KENWOOD

ASB-1060

Service Bulletin

Subject: TM-733A PL Tone Distortion
2006

TX-RX Unit (X57-4360-00)
Foil Side View

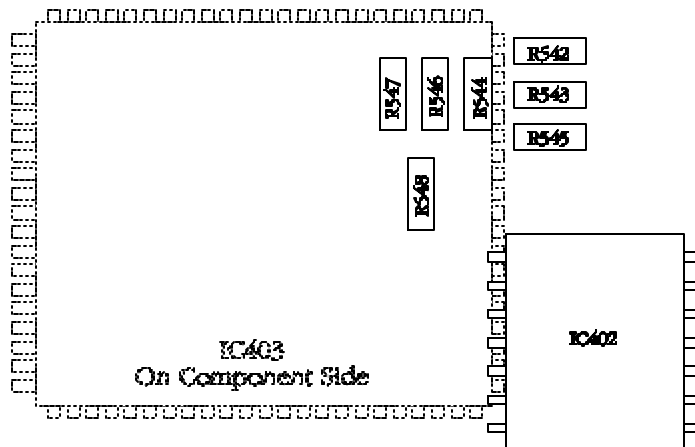
Transmitted PL Tones at the receiving station have a relatively high level of distortion. This is easily seen when the incoming signal is viewed on an oscilloscope.

Change the value of the "Pull-up" resistors in the PL tone encoder circuit as shown in the accompanying chart and illustration. This reduces the distortion from around 9% to approximately 4%.

Qty	Description	Old Kenwood Part No.	New Kenwood Part No.
1	R542 (from 1.8K to 2.7K)	RK73FB2A182J	RK73FB2A272J
1	R543 (from 1.8K to 3.3K)	RK73FB2A182J	RK73FB2A332J
1	R544 (from 1.8K to 4.7K)	RK73FB2A182J	RK73FB2A472J
1	R545 (from 1.8K to 6.8K)	RK73FB2A182J	RK73FB2A682J
1	R546 (from 1.8K to 10K)	RK73FB2A182J	RK73FB2A103J
1	R547 (from 1.8K to 10K)	RK73FB2A182J	RK73FB2A103J
1	R548 (from 1.8K to 10K)	RK73FB2A182J	RK73FB2A103J

8. Turn the circuit board over and replace the resistors using the parts list and illustration as a guide.
9. Reverse steps 1-7 for reassembly.
